Project: **La Jara Dental Clinic – Addition & Remodel** Project No.: 2614

Addendum No.: **02**

Date: **09/14/2026**

E121

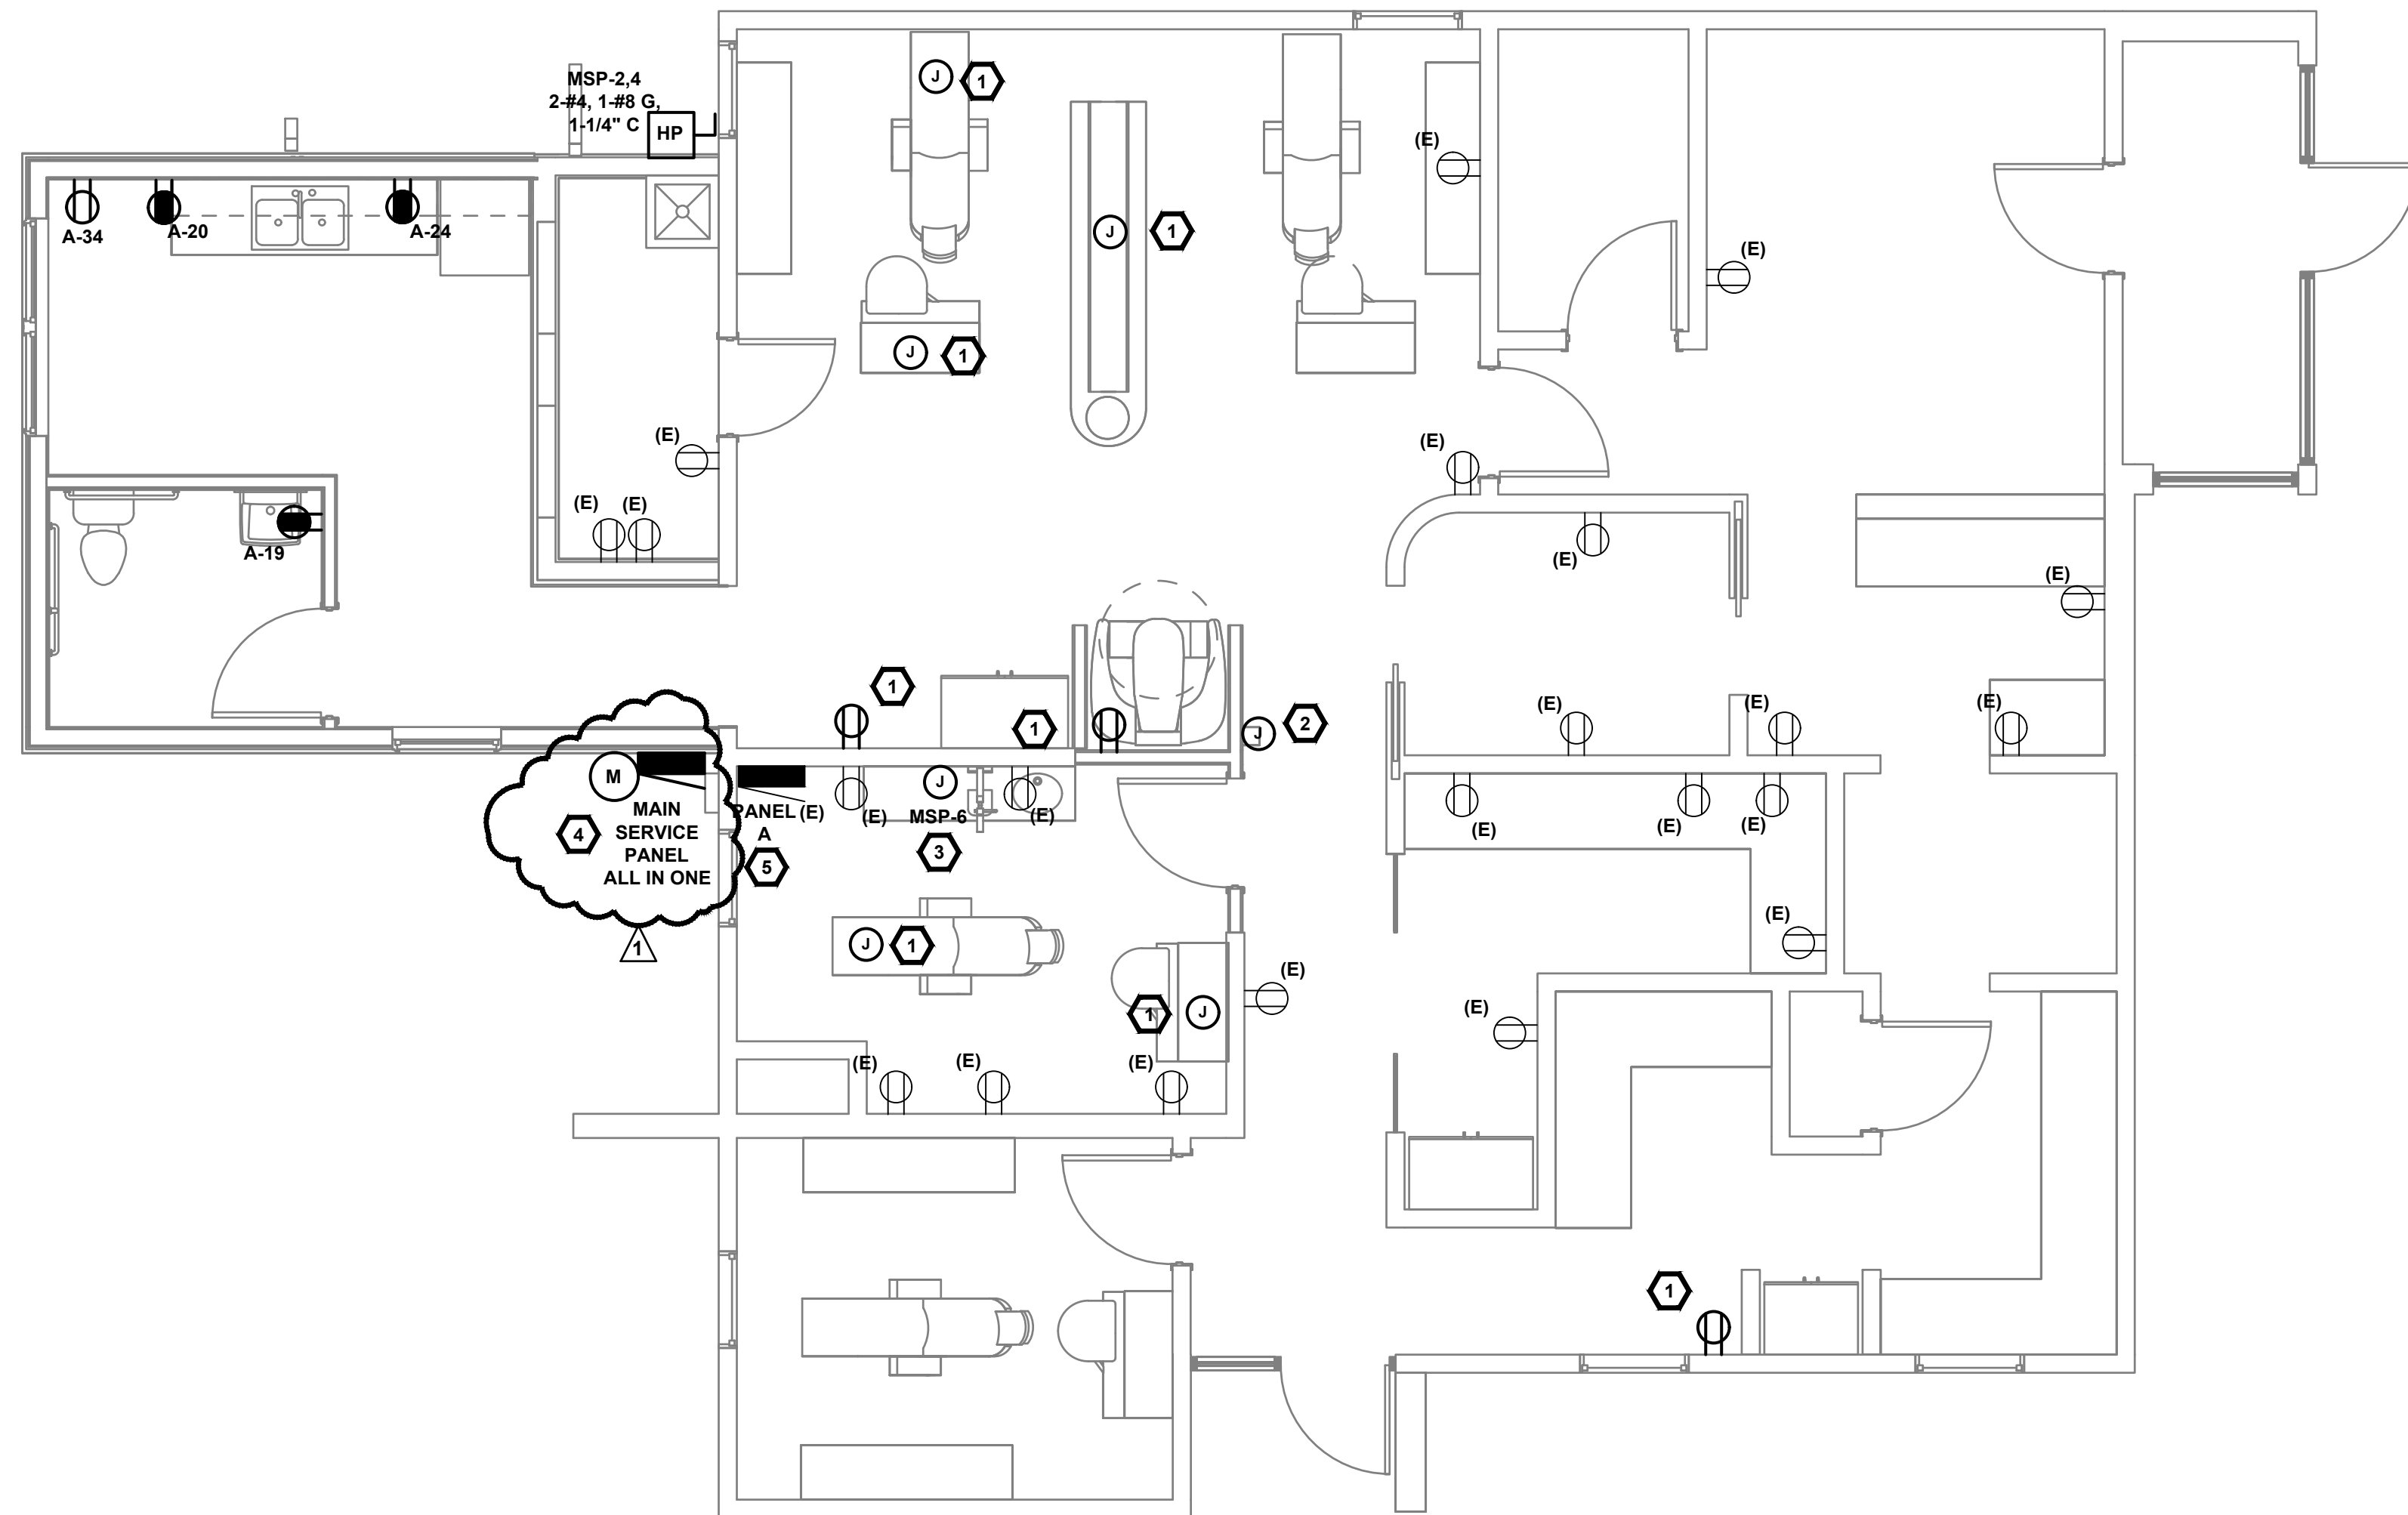
- a. T-001: Include \$5,000 allowance noted above. This requirement has been added to cover sheet.
- b. AD-101 & A-101 & M-111: Scope added to demo work on West wall. Contractor is responsible for removing baseboard heater and wire mold along this wall. If wire mold is in use, reroute wire and new wire mold up over new hallway opening.
- c. AD101 & A-101: Existing access to crawl space needs to move. Remove existing panel and infill per A-101. New access will be in office 106. Confirm exact location with owner on site. Flooring and sub flooring to be demoed for new access. Existing access panel to be reused.
- d. A-101: Carpet tile specification added.
- e. PD-111 & P-111: Remove and relocate existing cleanout as noted.
- f. ED-121 & E-121 & E-601: New electric service needed. Demo existing. Contractor to re-feed existing panel A from new service.

- 1 CONTRACTOR TO VERIFY EXISTING CIRCUITS AND RELOCATE TO NEW LOCATION AS SHOWN ON POWER PLANS.
- 2 X-RAY REMOTE EXPOSURE BUTTON- FURNISH AND INSTALL CADDUIT WITH PULL STRING TO X-RAY. JUNCTION BOX TO MOUNT 60" AFF
- 3 PROVIDE JUNCTION BOX FOR X-RAY. VERIFY EXACT LOCATION WITH OWNER/GC PRIOR TO ROUGH-IN.
- 4 CONTRACTOR TO INSTALL NEW SERVICE AS SHOWN ON PLAN.
- 5 CONTRACTOR TO RE-FEED EXISTING PANEL A FROM NEW SERVICE.

E601

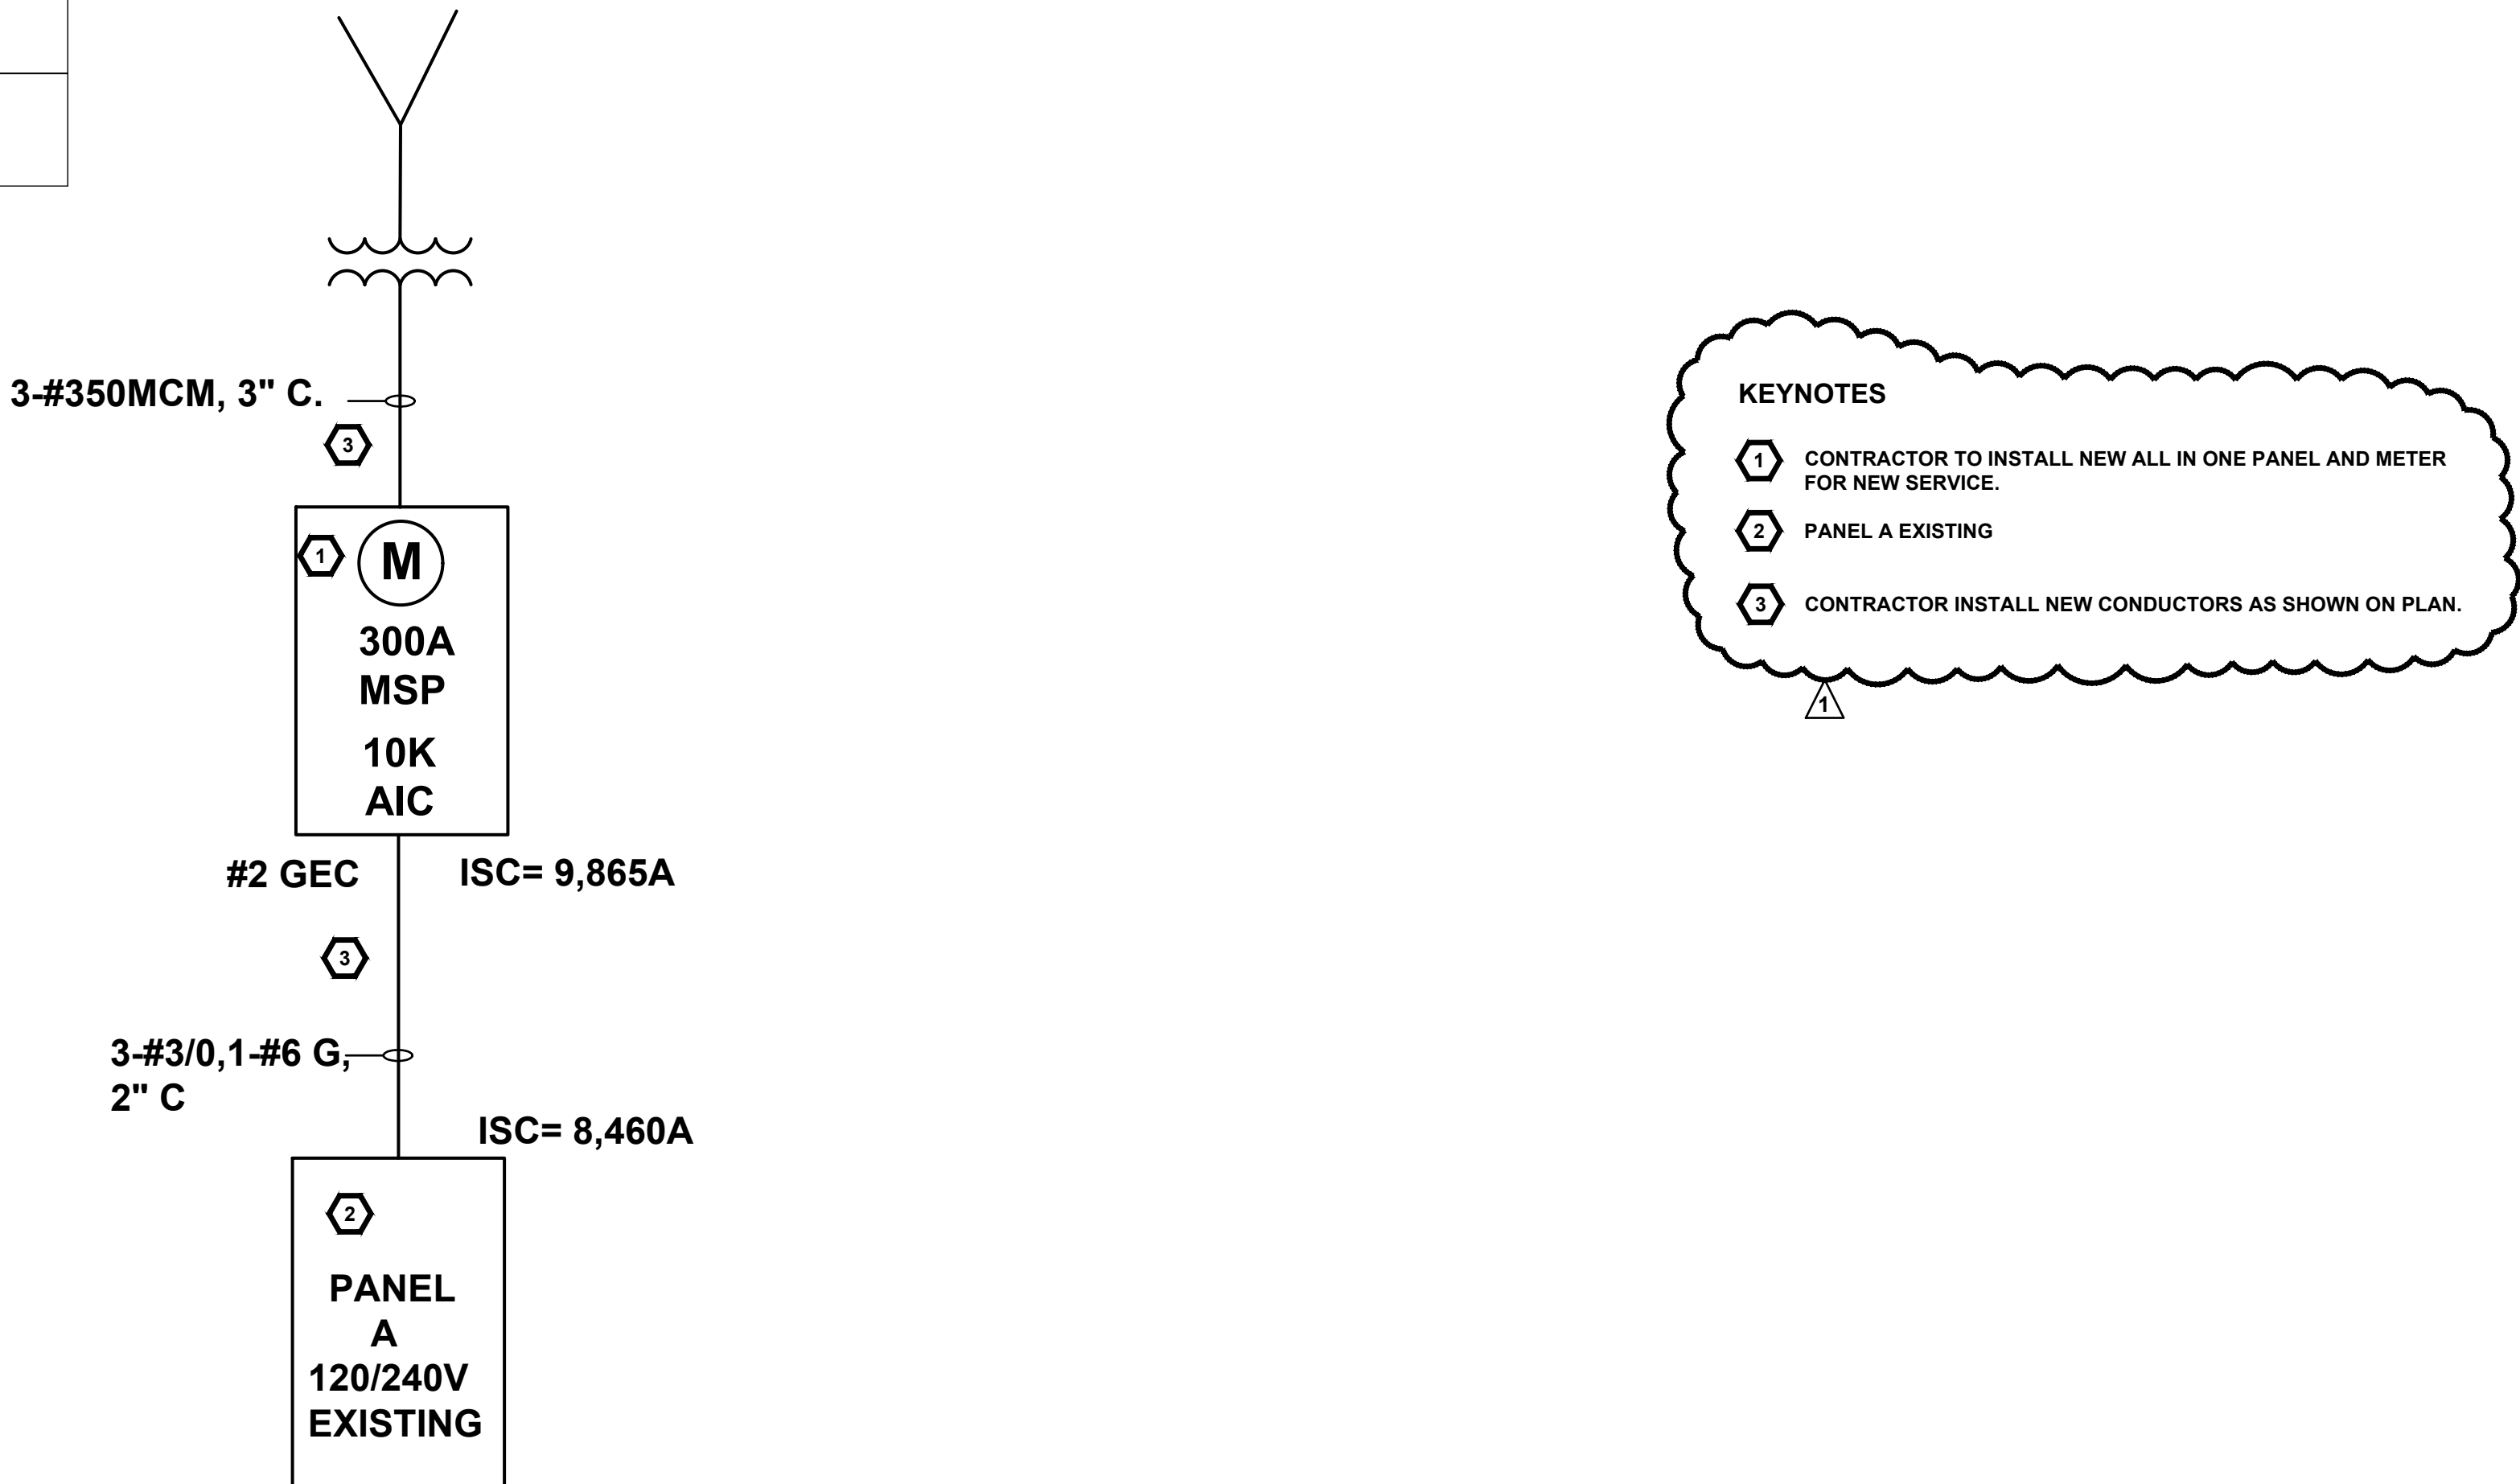
Sheet E601 identifies the existing MSP as 300 amps. However, the existing equipment appears to be a 200-amp service disconnect rather than an all-in-one panel, with no available space for new HVAC heat pump breakers. Please verify the existing service rating and provide the required electrical modifications to accommodate the new heat pump circuits. Service upgrade application is in-process.
